## **Tweed Sand Plant**

### **Flood & Stormwater Assessment**

Document No: BE190043-RP-FSA-04

In addition to the above-mentioned scope the following items were raised by Tweed Shire Council with respect to stormwater and flooding on the subject site (Council Reference: DA21/0233 LN 41917). A table has been prepared that summarises Burchills' response to the items raised by Tweed Shire Council.

Figure 3.2 Local Catchment Map and Flow Paths – Existing Case

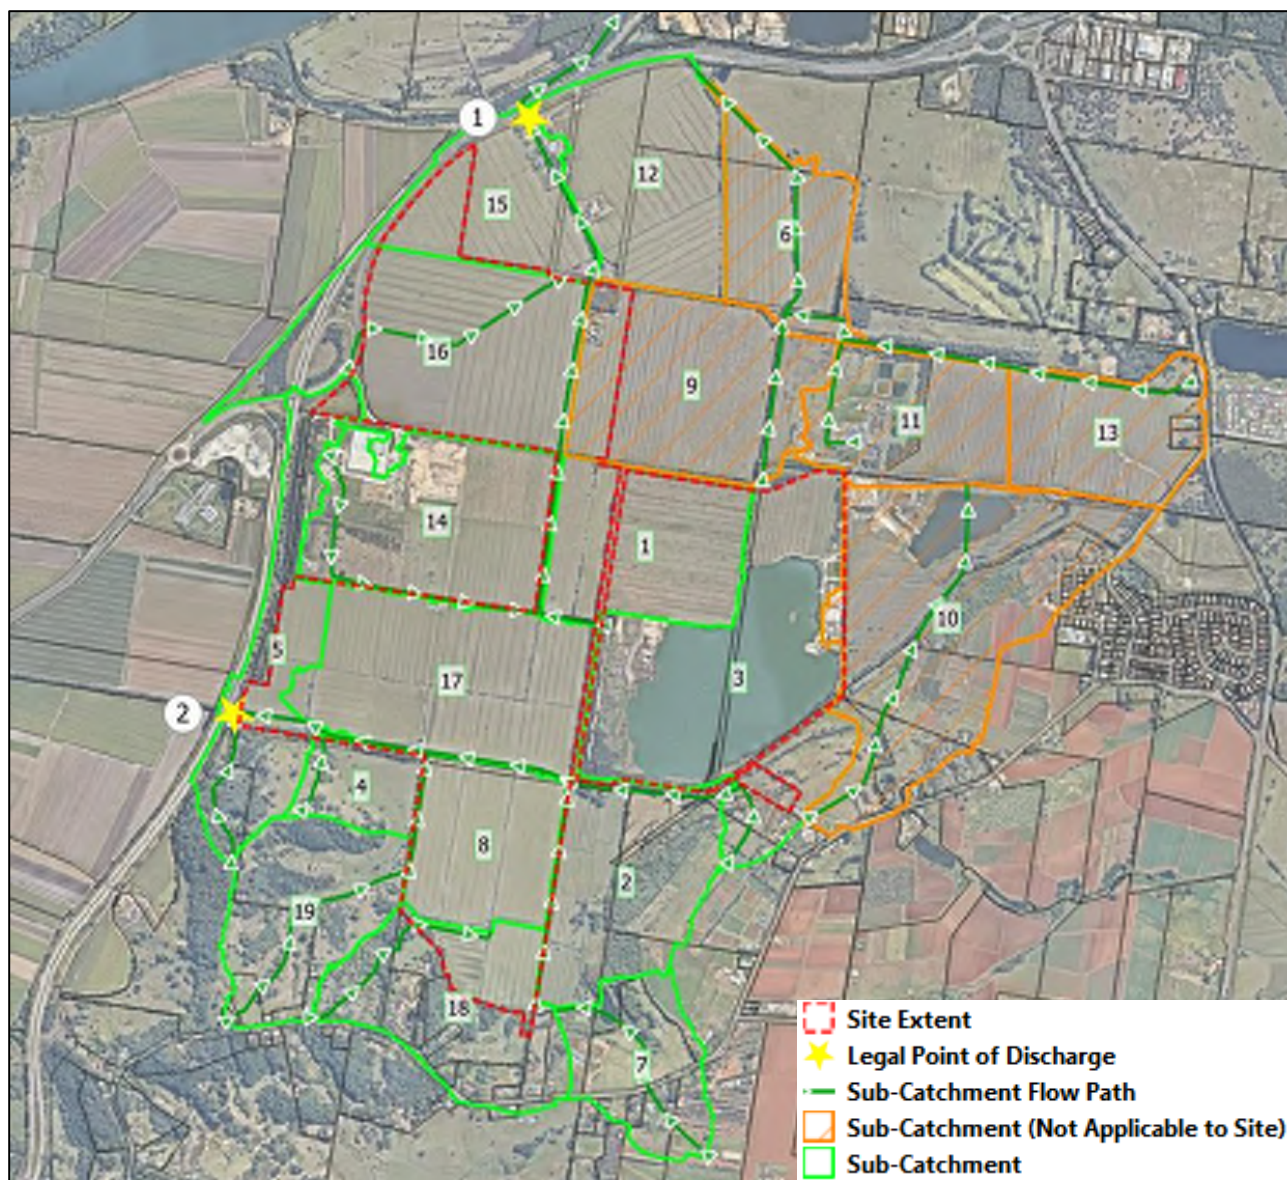
<p><b>C. Flood Assessment</b></p>	
<p>The assessment has not properly defined the external catchment influencing flood levels at the site (Figure 3.2). A local catchment flood assessment of the broader area undertaken for Gales by Venant Solutions established that during a 1% AEP event the drain along Altona Road flows from east to west towards the Hanson site. Further, this drain receives runoff from the catchment to the east of Tweed Coast Road.</p>	<p>As discussed above, the flood assessment has been updated to utilise Rain-On-Grid Modelling that accurately simulates the complex flow behaviour around the subject site.</p>
<p>There is no reporting of flood levels under existing and developed conditions at the eastern end of the site (western edge of Gales land) to demonstrate non-worsening.</p>	<p>Results discussion regarding hydraulic impact caused by the development is provided in <a href="#">Section 6.1 and 6.2</a>. Flood mapping has been provided in <a href="#">Appendix F</a>.</p>
